In reference to the Georgia Pacific Mill Race Trail, identified as Trail #4 in the City of Lebanon's adopted Trails Master Plan, the City of Lebanon has donated \$25,000 of Transit Lodging Tax funds towards the development of this specific trail segment. Once the trail is built by Build Lebanon Trails and is inspected to meet engineering and city standards, City staff will present the trail to the City Council with support and recommended action to accept the donation of the trail to the city.

**From:** Rodney Sell <rodneywsell@gmail.com>  
**Sent:** Thursday, December 19, 2024 7:33 AM  
**To:** Boles, Alyssa  
**Cc:** Thad Nelson; Board  
**Subject:** PD24-0237 The GPMRT  
**Attachments:** PTT Nimby submitted alternative GPMRT alignment12.18.24.docx

Re: PD24-0237

This letter is to serve as the open record response for the Linn County Planning Commission hearing on Planning File No. PD24-0237; a Condition Use Permit for a public trail on properties identified by the Linn County Tax Assessor Map No. T12S, R02W, Section 11AC, Tax Lot 1200 and T12S, R02W, Section 11BD Tax Lot 2000.

Alternate Route

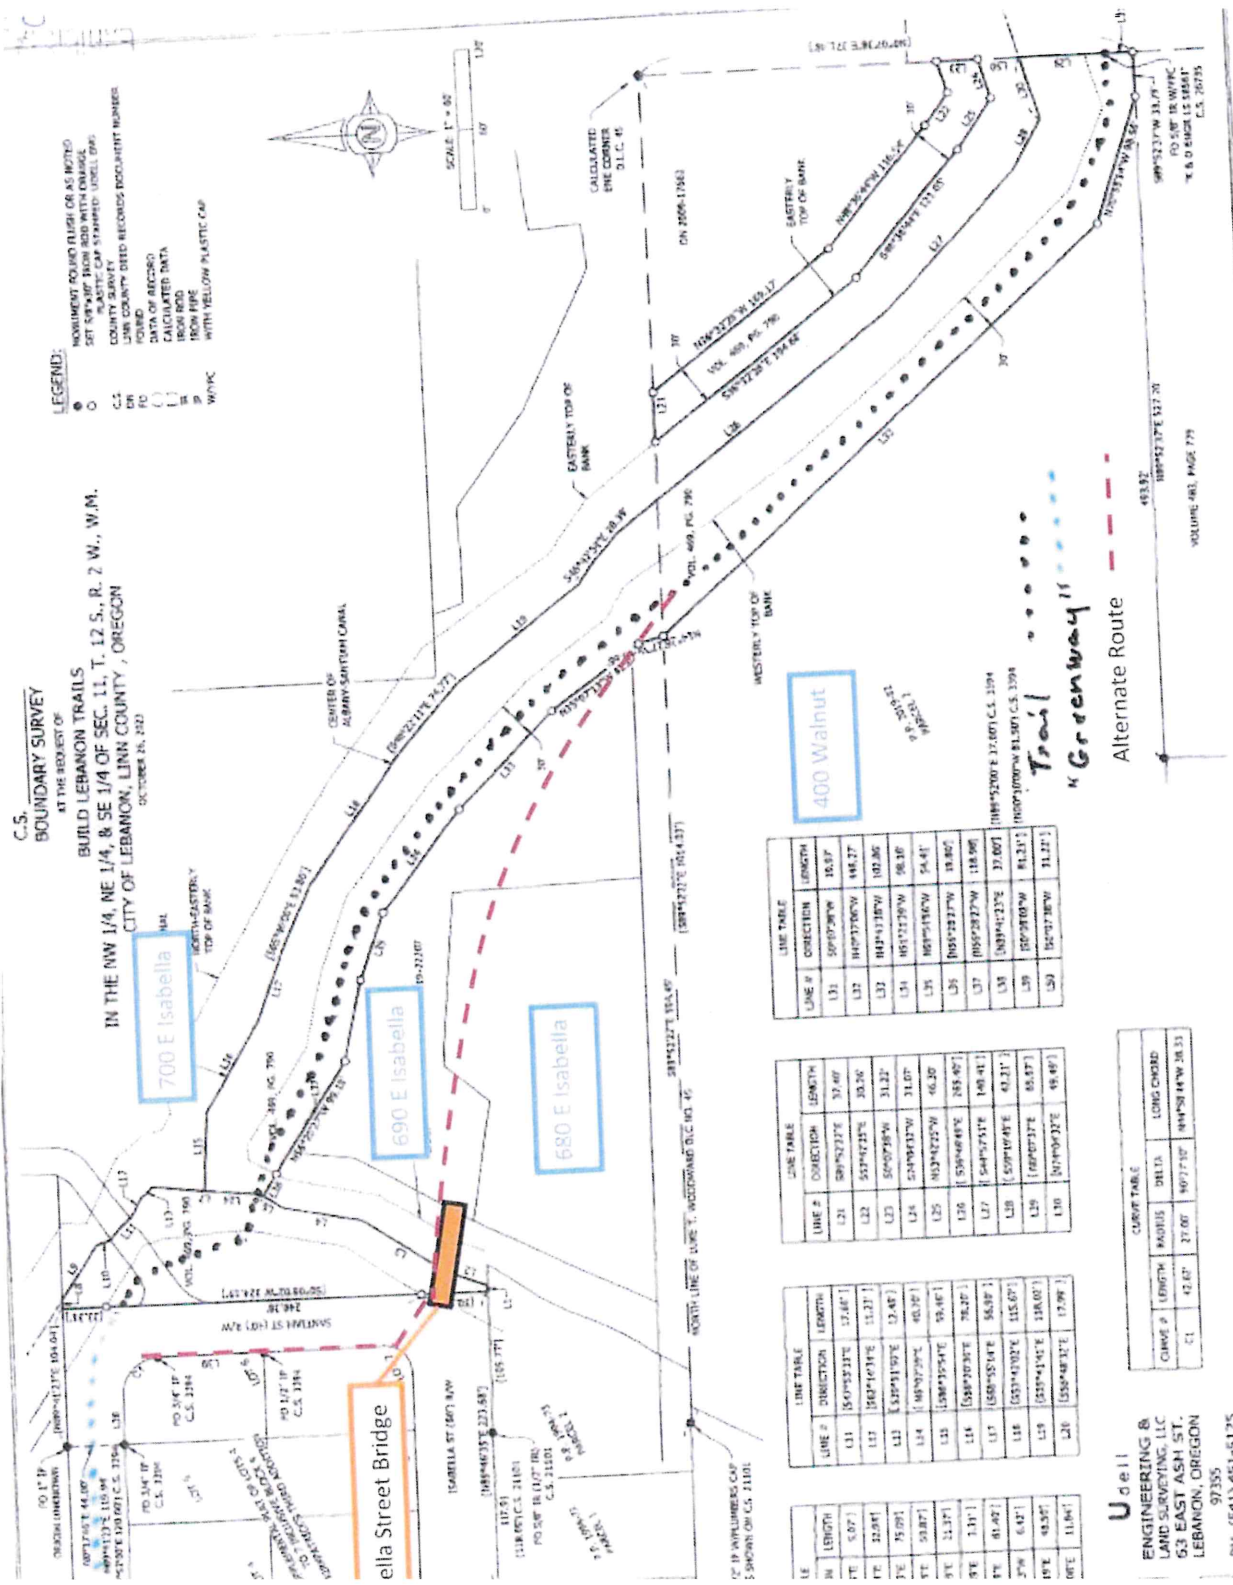
An alternative route such as the one shown in the attached map is one possible solution. It would still provide connectivity but terminate in a safer location on Santiam Street. This alignment satisfies concerns of the adjacent property owners and does not conflict with future streets and utilities needed to serve these same adjacent properties. Since the Mill Race Trail section has yet to be designed, changes are still possible.
